Service Bulletin

NO.	353
MODEL	
	ECV860
DATE ISSUED	DATE REVISED
5/17

ECV860 Governor Response Improvement

Figure 1. Original Governor Linkage Lever and Governor Spring.

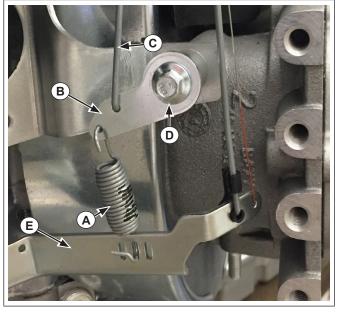
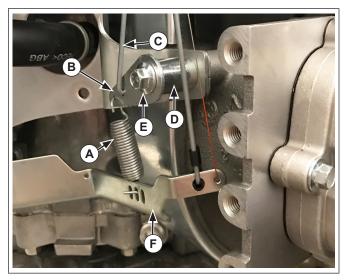
There have been isolated reports of low power on the ECV860-3019 engine. It has been determined that the governor droop (reaction to load) is too slow on some of these engines.

Replacing the original (see Figure 1) black governor spring (19 089 08) with an orange governor spring 19 089 05-S and replacing the original governor linkage lever (19 090 01) with a new design (see Figure 2) governor linkage lever 19 090 05-S that moves the governor spring hole location, should correct this situation.

1. Remove the M6 screw (D) securing the governor linkage lever (B). Unhook the speed control linkage (C) and governor spring (A) from the governor linkage lever (B). Save the screw (D) and spacer behind the governor linkage lever (B); discard the governor linkage lever (B). Remove the governor spring (A) from the governor lever (E); discard the governor spring (A). See Figure 1.

- 2. Hook the speed control linkage (C) and the new governor spring (A) into the new governor linkage lever (B). See Figure 2.
- 3. Hook the new governor spring (A) into the middle slot of the governor lever (F). Orient spring ends as shown in Figure 2. Secure the new governor linkage lever (B) and the spacer (D) with the M6 screw (E). Torque screw (E) to 10.2 N·m (90 in. lb.). See Figure 2.
